Addendum 02

MCSD Bid No.: 2024-7
Fremont ES, Muir ES, Chenoweth ES
Temporary Portable Classrooms & Sitework

Date : June 16, 2025
TETER Project No.: 24-13265,66,67

A110

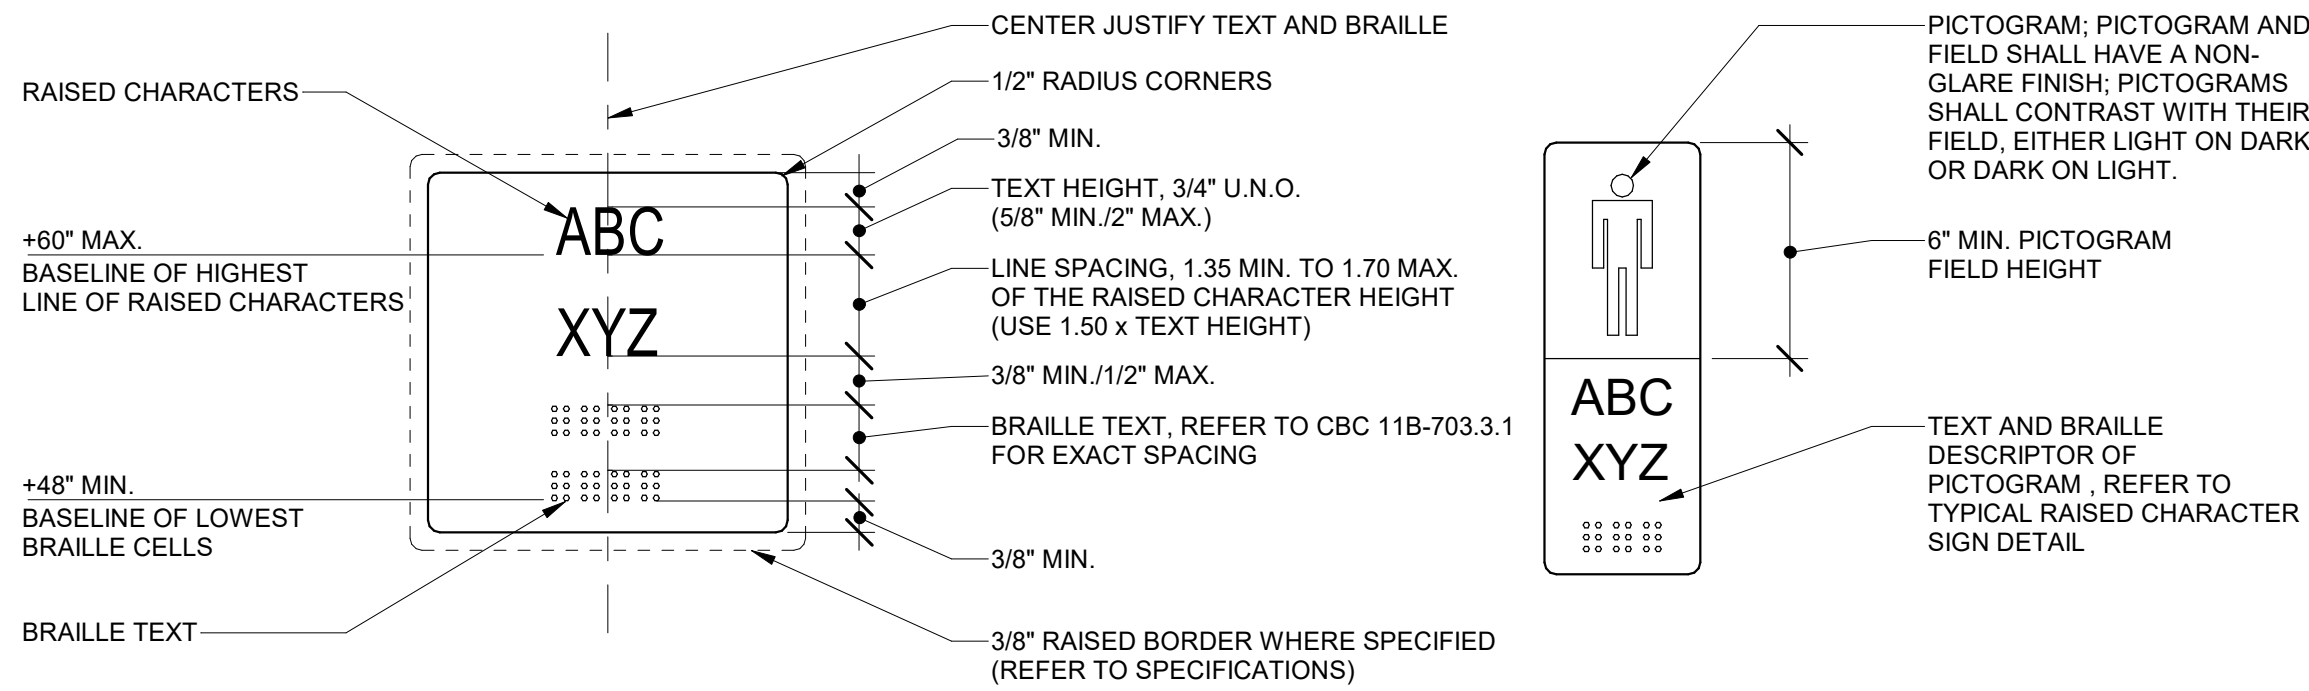
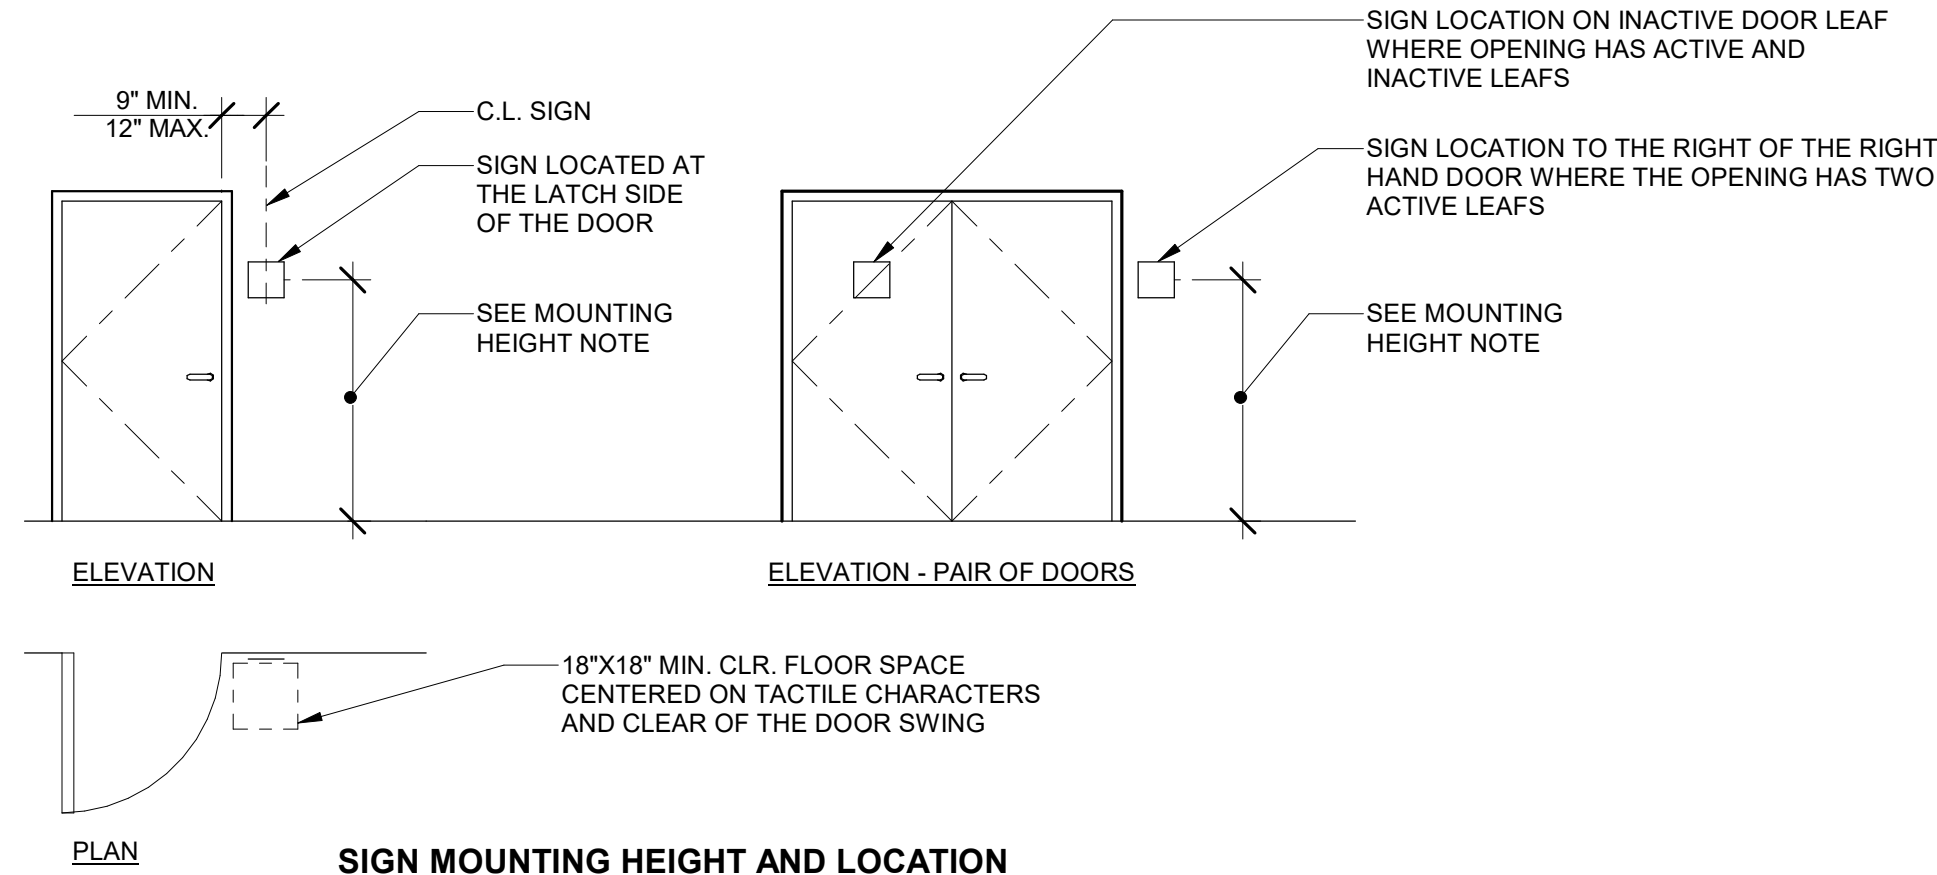
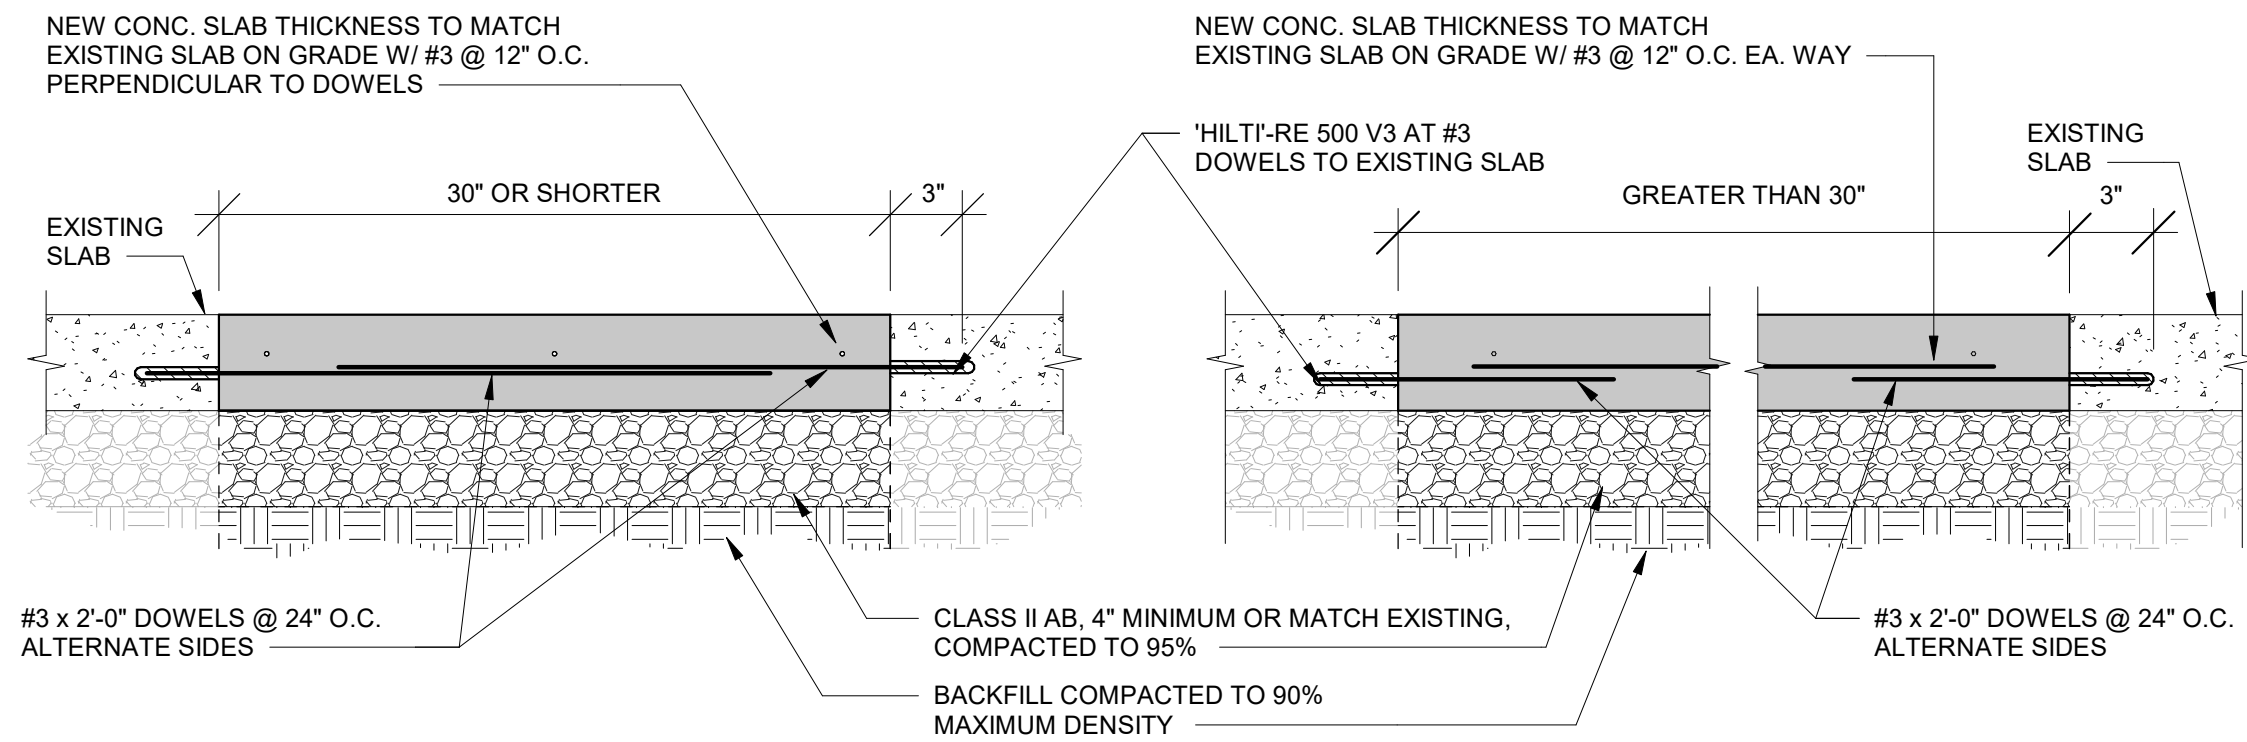
2 - 04: DRAWINGS, SHEET A110 – SITE DETAILS, is to be replaced with the attached drawing A110 in its entirety (1 page).

- A. Detail 2/A110 has been revised.

A101

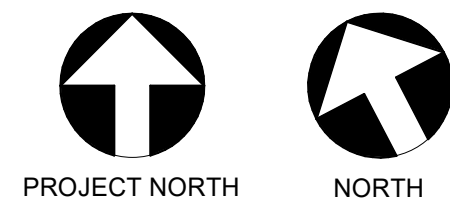
- 2 - 05: DRAWINGS, SHEET A101 – ENLARGED SITE PLAN**, is to be replaced with the attached drawing A101 in its entirety (1 page).
- A. Information has been added regarding the relocation of the existing storage container.
 - B. Information has been added regarding the extension of the existing concrete walkway.
- 2 - 06: DRAWINGS, SHEET A110 – SITE DETAILS**, is to be replaced with the attached drawing A110 in its entirety (1 page).
- A. Detail 16 has been added.

- 2.04 EXISTING CHAIN LINK FENCE
2.05 EXISTING GATE, TYP.
2.63 EXISTING STORAGE CONTAINER ~~TO BE~~ RELOCATED. EXTEND AND
RECONNECT ELECTRICAL SERVICE TO STORAGE CONTAINER
2.64 SET STORAGE CONTAINER ON NEW CONCRETE PAD IN LOCATION
INDICATED
10.11 ROOM SIGNAGE (RN-1), SEE
10.12 TACTILE EXIT SIGNAGE (TE-1), SEE
10.63 FIRE EXTINGUISHER, BRACKET MOUNTED
13.41 PRE-MANUFACTURED RAMP AND LANDING, HANDRAIL/ GUARDRAIL
SYSTEM. SEE RELOCATABLE MANUFACTURER DRAWINGS (DSA
#02-100168) 4 / A110
13.42 RELOCATABLE OVERHANG (SHOWN DASHED), TYP.
13.43 RELOCATABLE VENT LOCATIONS, TYP. SEE MANUFACTURER
DRAWINGS.
13.44 PROVIDE CLOSURE PANEL BETWEEN RELOCATABLES, SEE
13.45 FOR HANDRAIL EXTENSIONS, SEE
31.02 REMOVE EXISTING LANDSCAPING FOR PROPOSED CONCRETE
PAVING. RELOCATE IRRIGATION AS REQUIRED.
32.11 CONCRETE PAVING @ CONTAINER, SEE 12/A110
32.13 CONCRETE PAVING, SEE 1/A110
